Subject: MHI's Response to US-APWR DCD RAI No. 111-932 Revision 0

Response to Request for Additional Information
No. 111-932 Revision 0

**US-APWR Design Certification
Mitsubishi Heavy Industries
Docket No.52-021**

RAI NO.: NO.111-932 REVISION 0
SRP SECTION: 06.02.01.02 – Subcompartment Analysis
APPLICATION SECTION: MUAP-07031 Report
DATE OF RAI ISSUE: 12/3/2008

Table 1 time step selection for subcompartment analysis

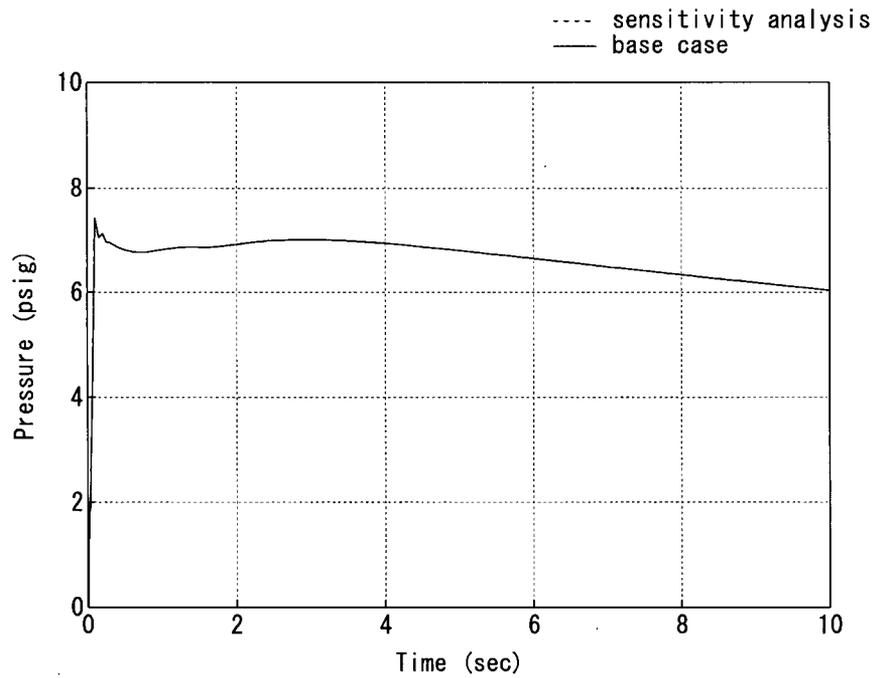
MUAP-07031 report: Although sensitivity of the results to time step variation in the cases presented was small, many variables impact correct time step selection. Please, include in the DCD additional justification and/or discussion regarding the selection of the time steps for the specific limiting cases presented in the DCD.

The sensitivity analyses were performed to confirm that the appropriate time step was selected for the US-APWR subcompartment analyses. The time step selection of the base cases (presented in MUAP-07031) and the sensitivity analyses are shown in Table 1. The limiting time steps for the sensitivity analyses are a half of those for the base cases.

Figure 1 Result of Nodalization Sensitivity Analysis
(PRZ Spray Line Break)

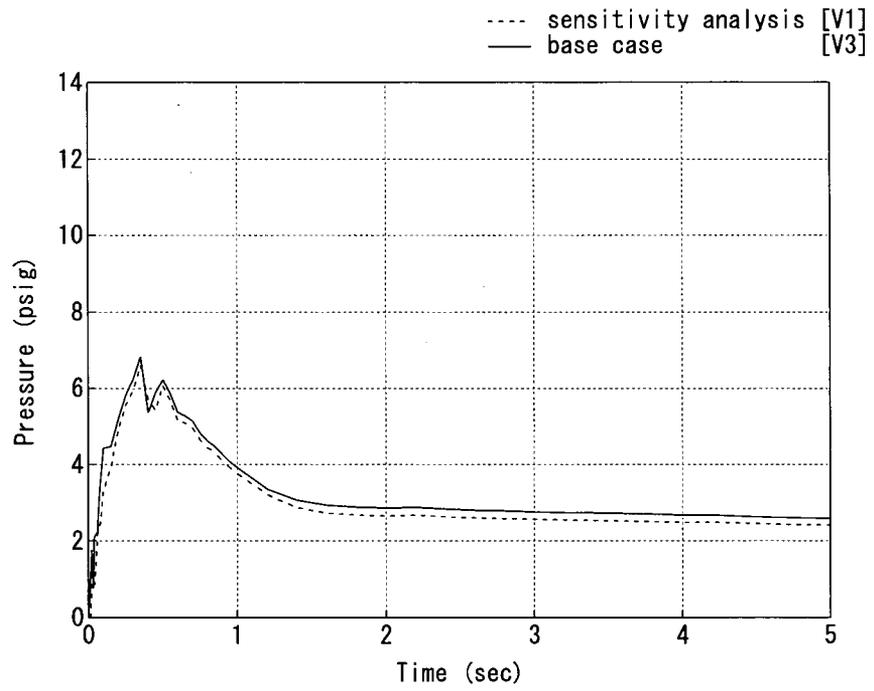
MUAP-07031 report: Section 6.4.1 include conclusion that nodalization is sufficient to calculate peak pressure differences. However, the figures 6.4-14 and 6.4-15 only show one curve that is not labeled. Please, provide a comparison plots of pressures for each nodalization scheme and selected volume to clarify potential misunderstanding.

Figure 1 and 2 shows the result of the sensitivity analysis of nodalization scheme in comparison with the base case. Figure 1 shows the result of PRZ spray line break case and figure 2 shows the result of PRZ relief line break case. The pressure response for the sensitivity analysis case is similar to that for the base case. It was confirmed that base case nodalization is sufficient to calculate peak pressure differences for postulated pipe breaks inside the pressurizer compartment.

The figures will be modified in the next revision of the MUAP-07031.

Figure 1 Short term mass and energy release data for reactor cavity analysis (1/2)
Direct vessel injection line break

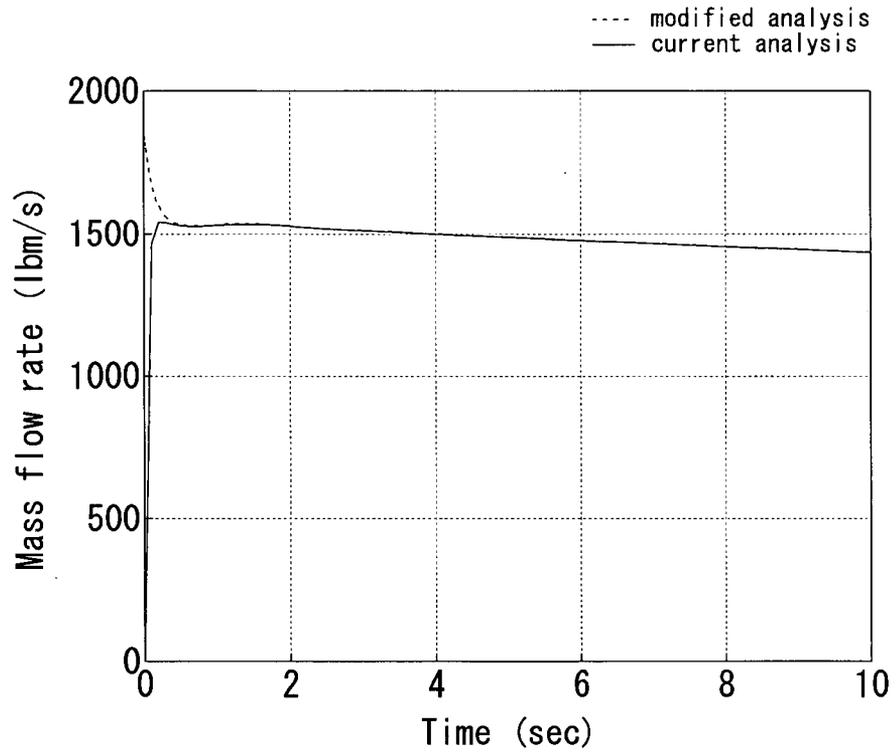
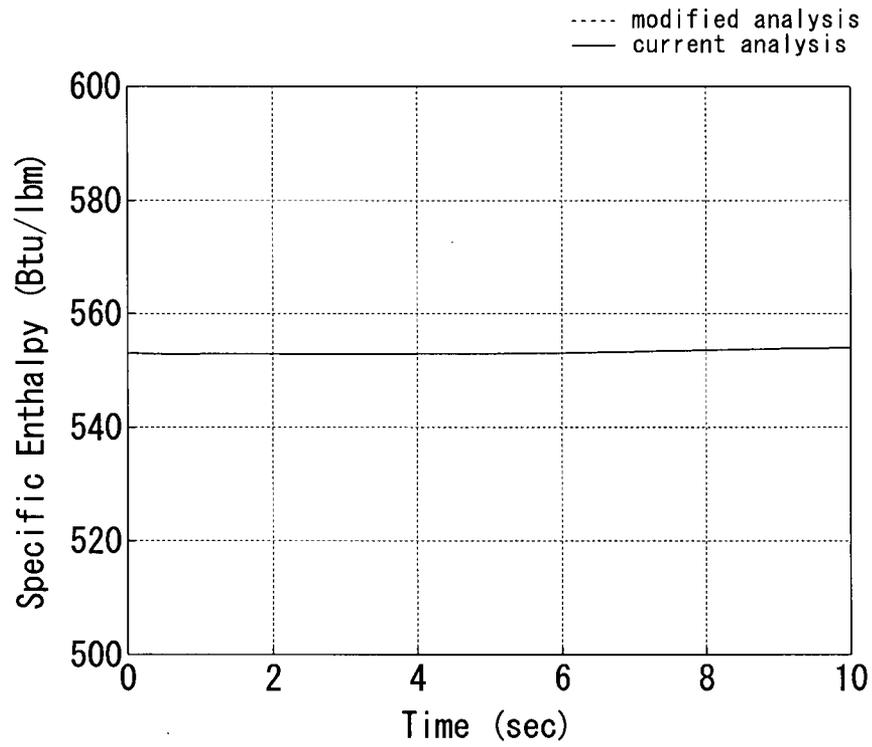
MUAP-07031 report: Sufficient information needs to be provided by Mitsubishi allowing staff to perform independent evaluation of both the subcompartment analysis itself as well as the mass and energy release calculations used in the subcompartment analysis. Specifically, staff selected SG compartment and reactor cavity cases to perform confirmatory calculation. Please, provide the masses and energy release and nodalization details used in Mitsubishi analyses of the two cases.

The input deck of M-RELAP5 for DVI (Direct Vessel injection) break mass and energy release used for reactor cavity subcompartment analysis is provided as digital file. The DVI mass and energy release analysis was modified from the case presented in MUAP-07031 to obtain the conservative mass and energy release results (See response to RAI-06.02.01.02-2). Attached input deck is the modified version. The result of modified mass and energy release analysis for DVI break is shown in Figure 1 in comparison with previous result (presented in MUAP-07031).
